112053 - 00

Change Notification #: 112053 - 00
Change Title: Intel® Server Chassis P4304XXSHCN and Intel® Server System P4304BTLSHCNR PCN 112053-00, Product Design Thumb-Screw Length Change
Date of Publication: February 04, 2013

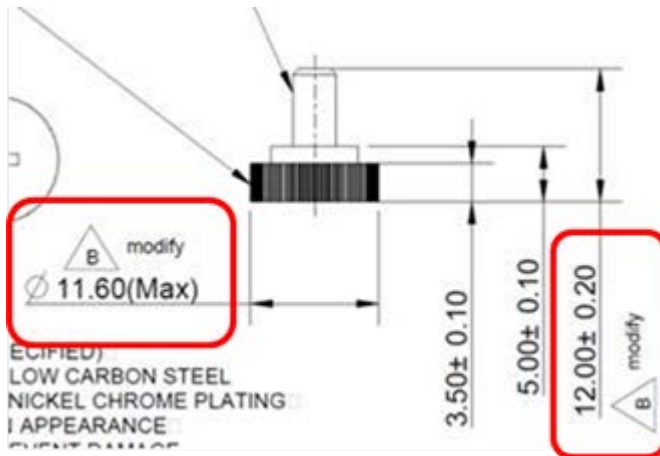
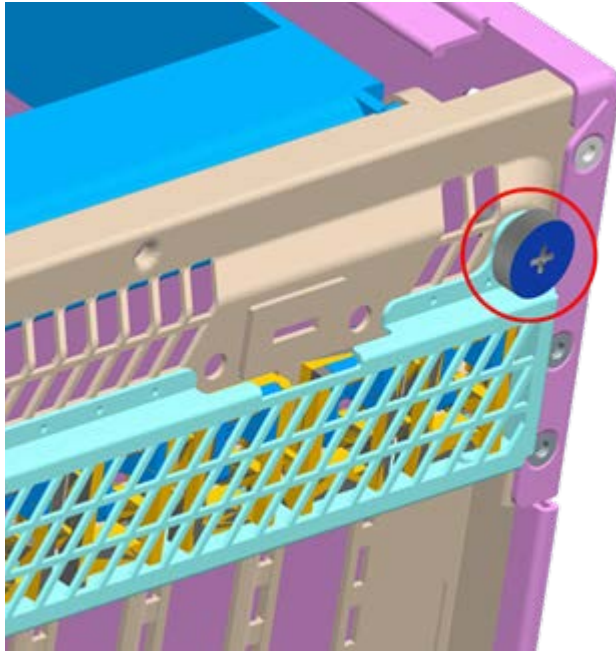
- The Thumb-Screw will change length from 5mm to 7mm and dimension from 12.8mm to 11.6mm to support the assembly of RMM4 module EMI bracket. See below pictures.
